DTNA Solutions › Service Solutions › Thomas Built Bus
› SS 293 TBB Wiper Module TBB 61201552 replacement

SS 293 TBB Wiper Module TBB 61201552 replacement

61201552 has been replaced with either TBB 248062 or TBB 249465 replacement procedure.

TBBN248062 is for current production (76-way dash/chassis interface).

REMOVE WIPER DIODE BLOCK 61201552

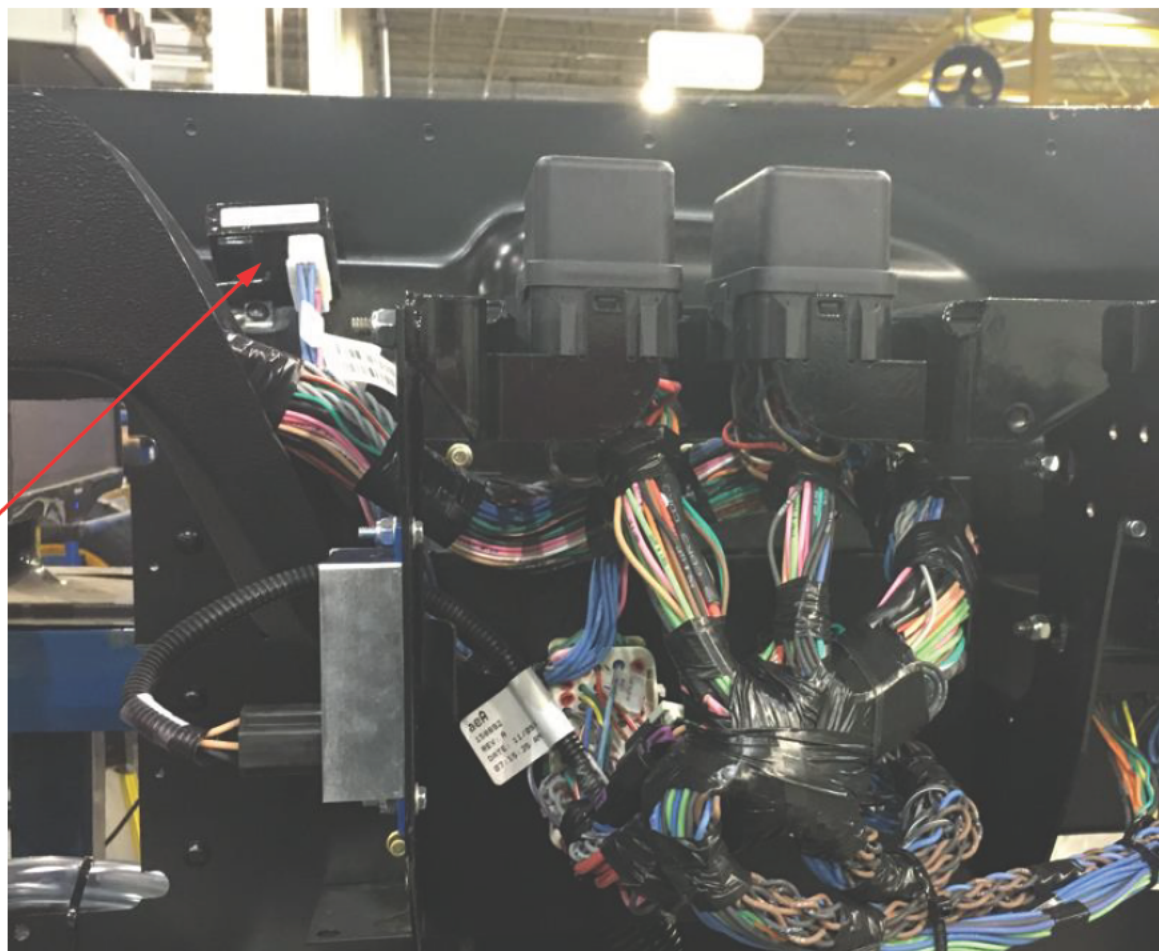
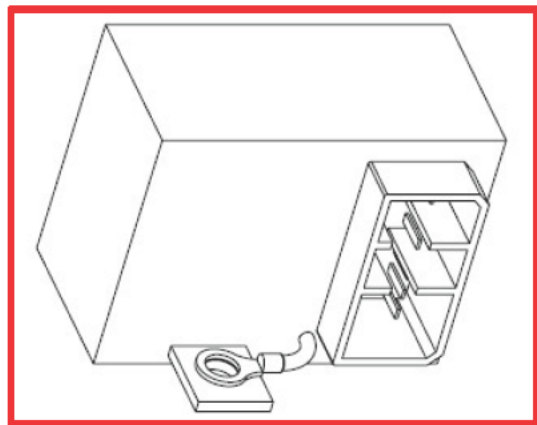
1. LOCATE THE WIPER DIODE BLOCK.
2. UNSCREW MOUNTING TAB AND REMOVE IT FROM THE FRONTWALL.
3. DISCONNECT THE HARNESS FROM THE DIODE BLOCK.
4. TIE BREAKOUT HARNESS TO THE MAIN BUNDLE.
5. DISCARD WIPER DIODE BLOCK 61201552.

ADD ITEM 000 - 248061

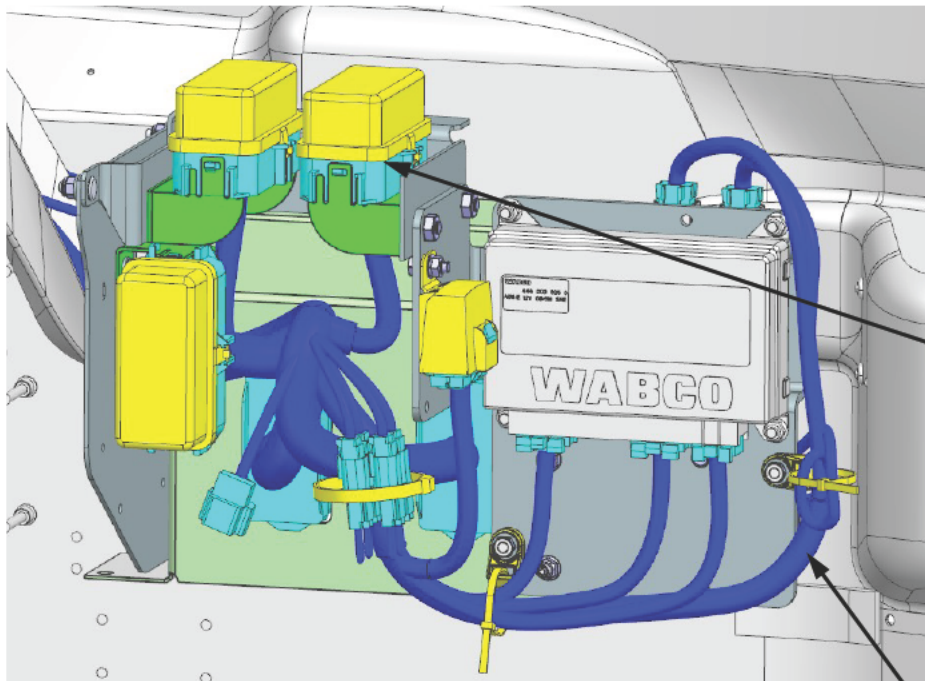
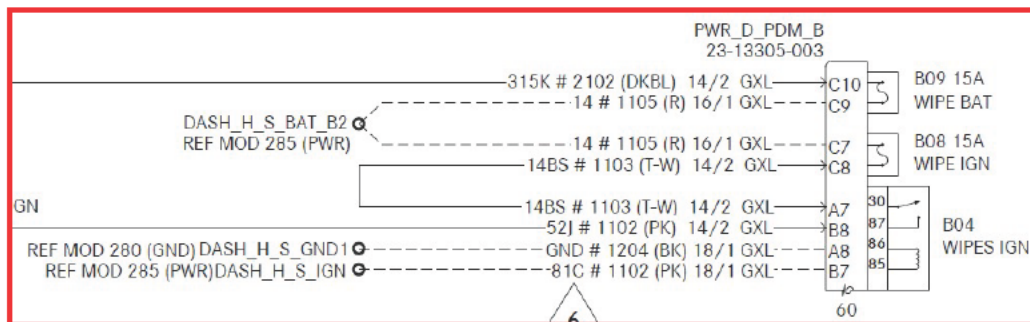
1. ON **PWR_D_PDM_B**, REMOVE THE EXISTING CIRCUITS ON (PIN: A7, B8, C8, & C10). ON ITEM 000, LOCATE THE PROPER CIRCUIT# TO THAT CONNECTOR AND INSERT THE WIRE TERMINALS TO THE PROPER CAVITY. ENSURE TO REUSE THE SAME FUSES AND RELAY.
2. TAPE THE EXISTING UNUSED CIRCUIT TERMINALS BACK TO THE MAIN BUNDLE.

ADD ITEM 000 - 248061

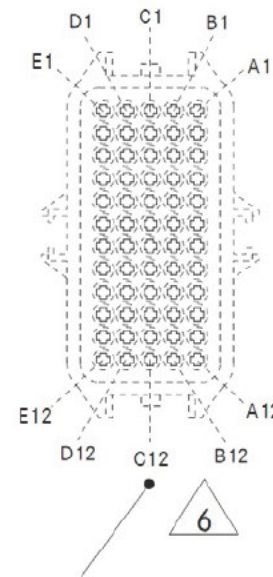
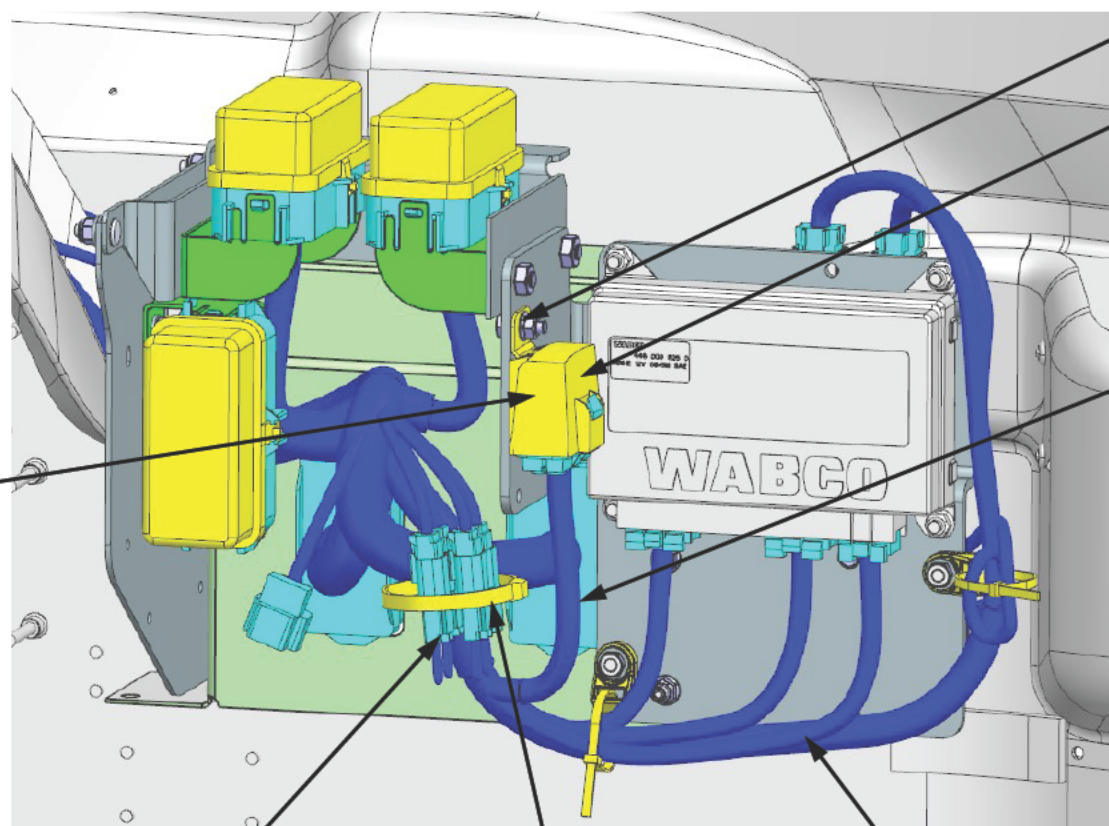
1. MOUNT **DASH_H_WPR_RLY_HLDR** TO THE PDM BRACKET AS SHOWN.
2. ROUTE AND ZIP TIE ITEM 000 TO THE MAIN BUNDLE.
3. ADD ITEM 600 TO THE RELAY HOLDER COVER.

ADD ITEM 001 – 248463

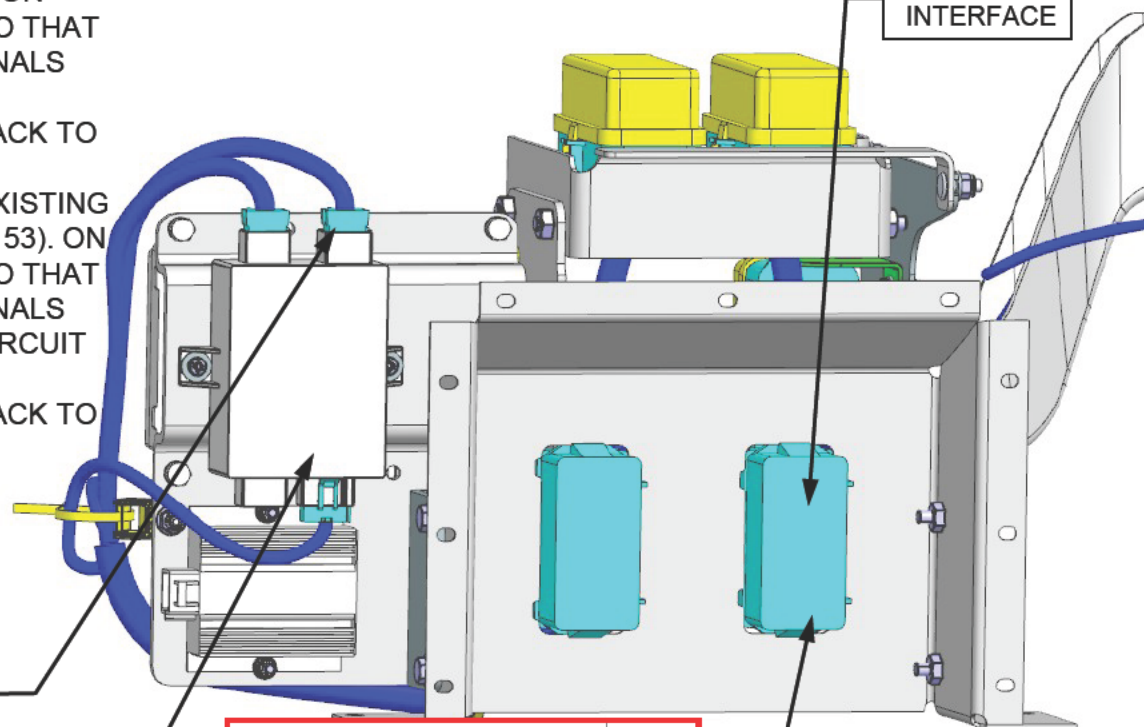
1. ON **CHAS_H_DASH_BKD_B**, REMOVE THE EXISTING CIRCUITS ON (PIN: 40, 41, 42, 43, 44, 45, 52, & 53). ON ITEM 001, LOCATE THE PROPER CIRCUIT# TO THAT CONNECTOR AND INSERT THE WIRE TERMINALS TO THE PROPER CAVITY INCLUDING GND CIRCUIT TO PIN 72.
2. TAPE THE EXISTING UNUSED TERMINALS BACK TO THE MAIN BUNDLE.
3. REMOVE THE EXISTING CONNECTOR ON THE LEFT & RIGHT WIPER MOTOR. MATE THE NEW WIPER HARNESS BREAKOUT TO THE PROPER WIPER MOTOR.
3. ZIPTIE THE HARNESS TO THE MAIN BUNDLE.

ITEM 001 – 248463

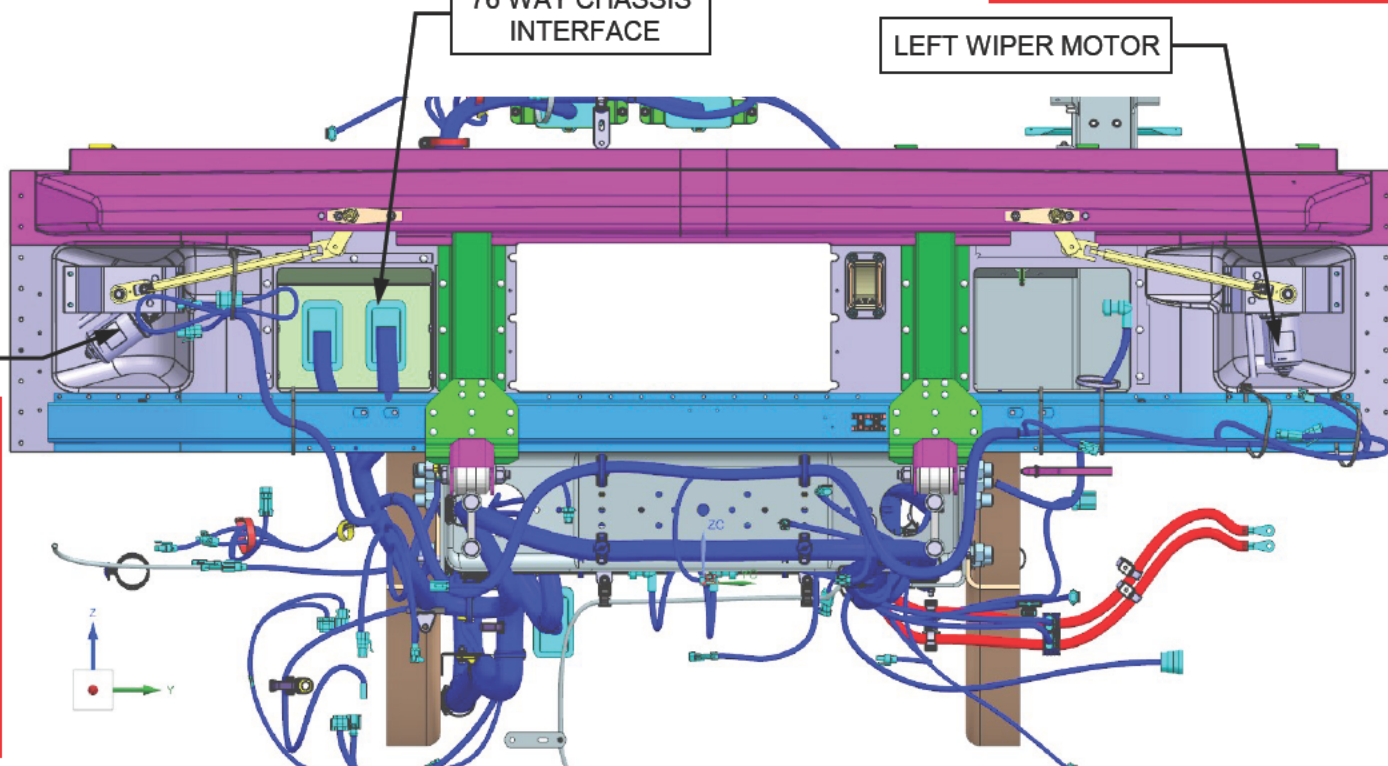
1. TAKE **CHAS_H_DASH_WPR_RLY_GND** RING TERMINAL TO THE EXISTING GROUND STUD AT THE FRONT RIGHT HAND RAIL. USE EXISTING HARDWARE.
2. ZIPTIE THE BREAKOUT HARNESS TO THE MAIN BUNDLE.

REMOVE WIPER DIODE BLOCK 61201552

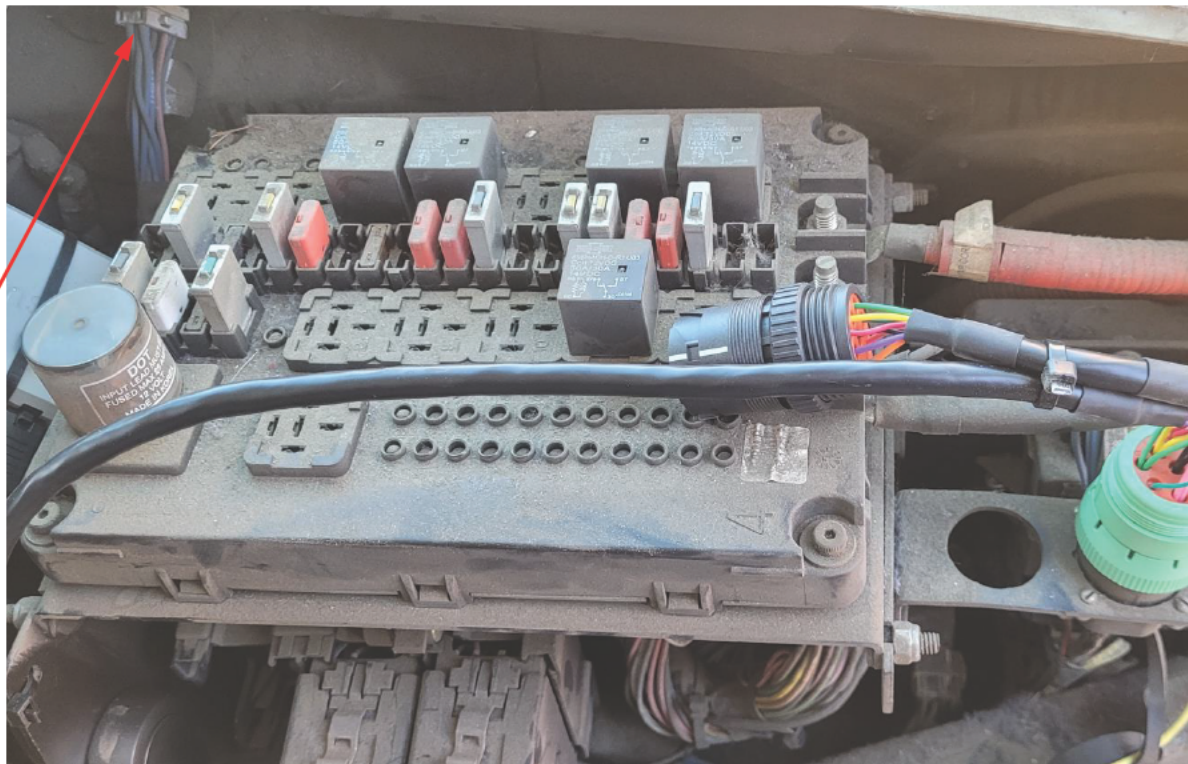
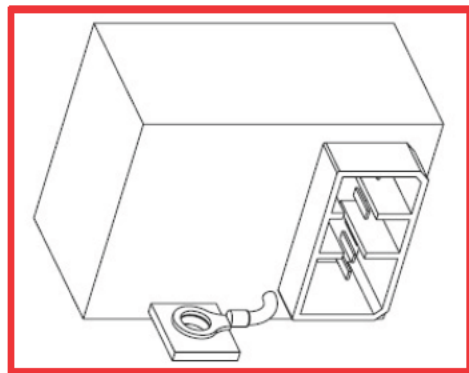
1. LOCATE THE WIPER DIODE BLOCK.
2. UNSCREW MOUNTING TAB AND REMOVE IT FROM THE FRONTWALL.
3. DISCONNECT THE HARNESS FROM THE DIODE BLOCK.
4. TIE BREAKOUT HARNESS TO THE MAIN BUNDLE.
5. DISCARD WIPER DIODE BLOCK 61201552.

ADD ITEM 000 - 249462

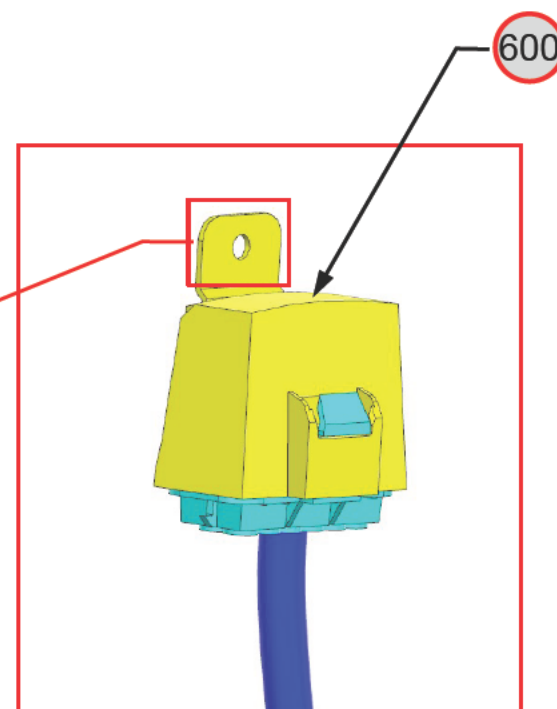
1. MOUNT **DASH_H_WPR_RLY_HLDR** TO THE PDM BRACKET. USE EXISTING HARDWARE.
2. ADD ITEM 600 TO THE RELAY HOLDER CAP.

ADD ITEM 000 - 249462

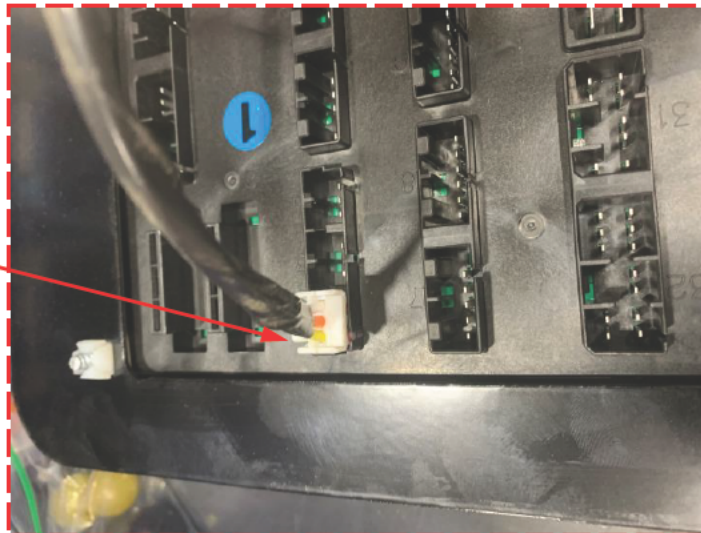
1. LOCATE THE PCB-1 BODY BOARD ON THE SIDE PANEL UNDER THE DRIVER'S WINDOW.
2. REMOVE THE EXISTING CONNECTOR ON PLUG 16.
3. ON ITEM 000, FIND CONNECTOR **DASH_H_WPR_PWR_P16** AND CONNECT TO PLUG 16.

ADD ITEM 001 - 249463

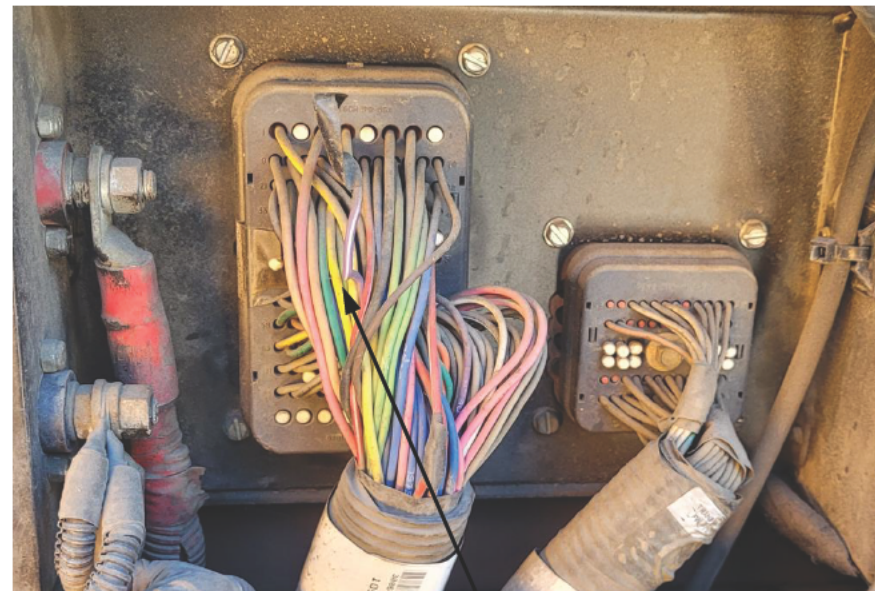
1. ON **DASH_H_FW_J76**, REMOVE THE EXISTING CIRCUITS ON (PIN: 16, 27, 28, 29, 30, 31, 32, 33, 34 & 95). ON ITEM 000, LOCATE THE PROPER CIRCUIT# TO THAT CONNECTOR AND INSERT THE WIRE TERMINALS TO THE PROPER CAVITY.

2. ON **CHAS_H_FW_P76**, REMOVE THE EXISTING CIRCUITS ON (PIN: 27, 28, 29, 30, 31, 32, 33, 34 & 95). ON ITEM 000, LOCATE THE PROPER CIRCUIT# TO THAT CONNECTOR AND INSERT THE WIRE TERMINALS TO THE PROPER CAVITY.

ADD ITEM 001 - 249463

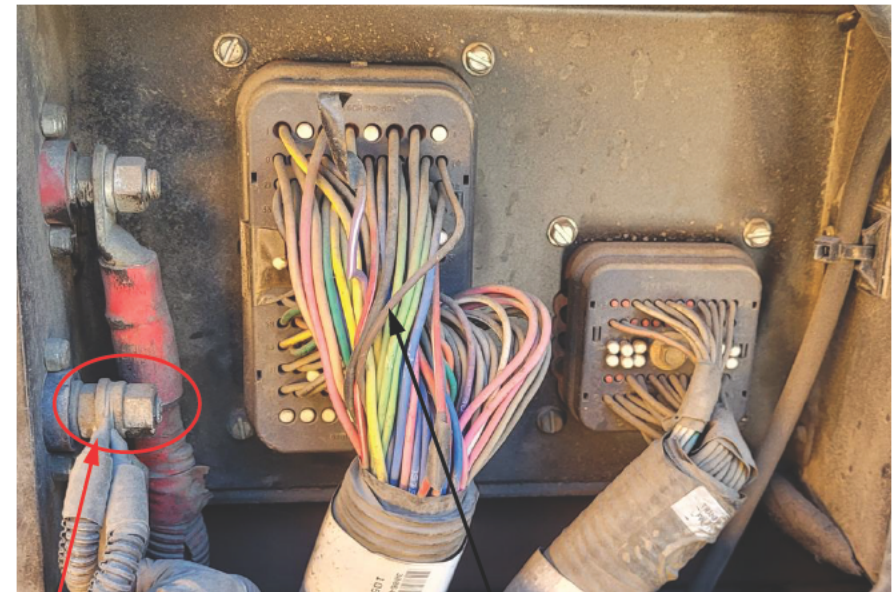
1. ON ITEM 001, FASTEN **CHAS_H_DASH_WPR_RLY_GND** RING TERMINAL TO THE EXISTING GROUND STUD BY THE 102 WAY. USE EXISTING HARDWARE.
